**ZONING AMENDMENT &
PLANNED UNIT DEVELOPMENT
STAFF REPORT**

Date: August 18, 2011

| <u>DEVELOPMENT NAME</u> | Rich's Car Wash |
| <u>LOCATION</u> | 1066 Hillcrest Road (Northwest corner of Hillcrest Road and Johnston Lane) |

SITE PLAN

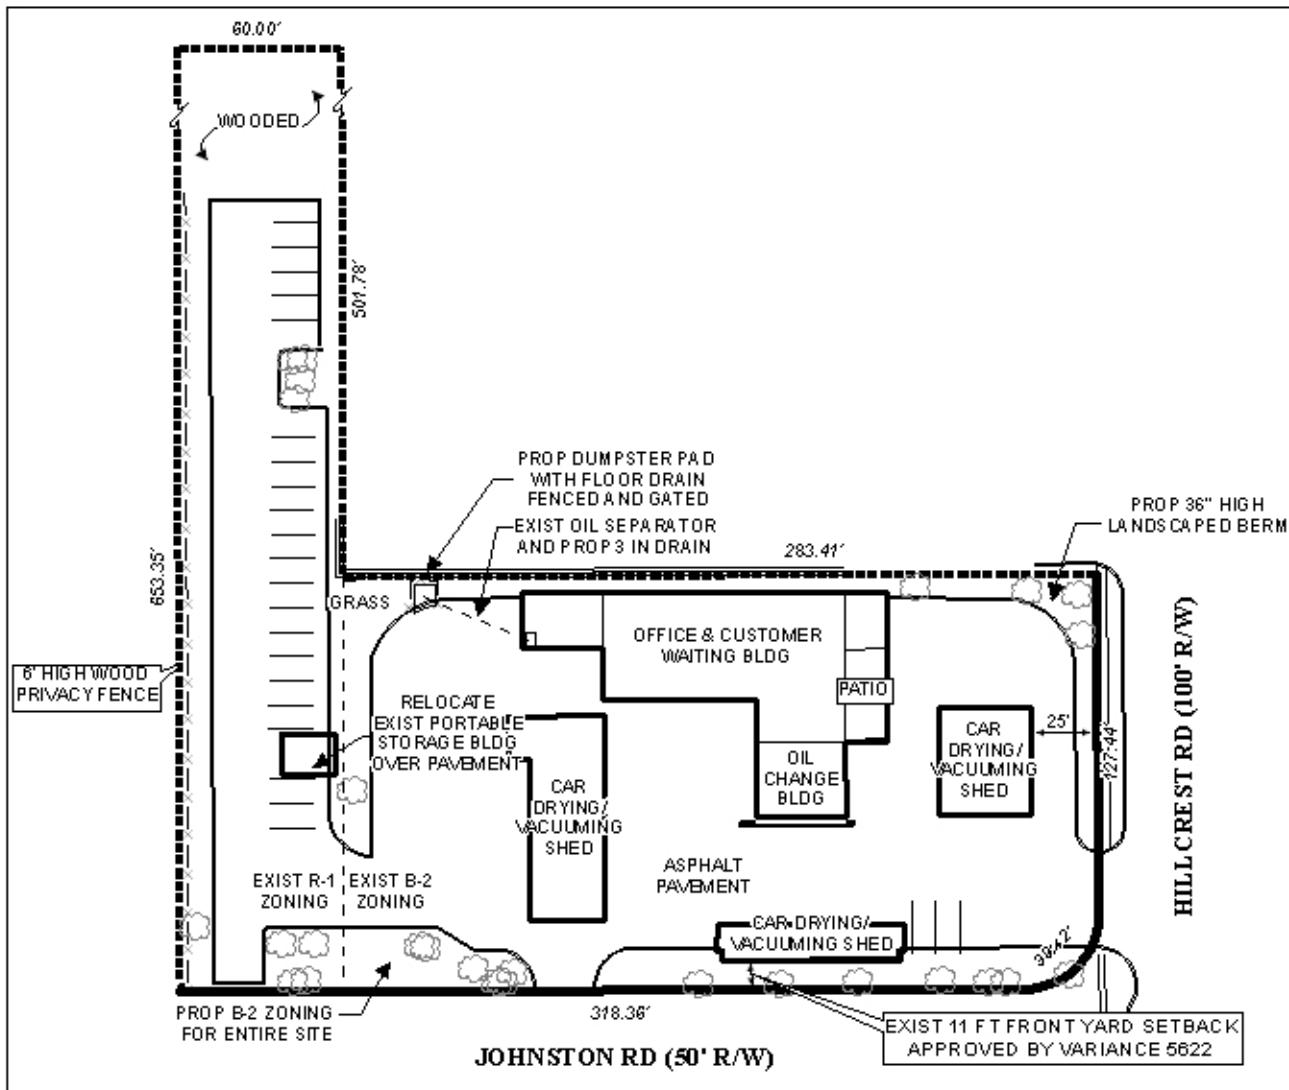
- 1) *revision of the site plan to indicate a 6' high wooden privacy fence along the entire Western boundary of the site, except no higher than 3' high within the Johnston Lane 25' setback;*
- 2) *revision of the site plan to indicate either a zero or 5'-plus side yard setback for the dumpster;*
- 3) *revision of the site plan to indicate proper dumpster screening or the placement of a note on the site plan stating that the dumpster will be completely screened from view; and*

- 4) revision of the site plan to relocate the portable storage building to a compliant area of the site out of the drainage and utility easement and not displacing any required parking.

The applicant has submitted a site plan with the required revisions meeting compliance with the Zoning Ordinance. The portable storage building has been relocated to an area partially in the parking lot and partially on the landscaped area; however, the two parking spaces it occupies have been provided elsewhere on site, and the site has adequate landscaping area to allow the loss due to the building site coverage.

- 1) placement of a note on the site plan stating that the runoff from the vehicle washing facility must drain to the sanitary sewer system, and the connection must include an oil separator;
- 2) placement of a note on the site plan stating that the dumpster pad must connect to the sanitary sewer system via a grease trap/oil separator;
- 3) placement of a note on the site plan stating that any new lighting on the site will comply with Section 64-4.A.2. and 64-6.A.3.c. of the Zoning ordinance;
- 4) obtaining of all necessary after-the-fact building permits for the portable storage shed; and
- 5) submittal of two copies of a revised PUD site plan including the above conditions to the Planning Section of Urban Development.
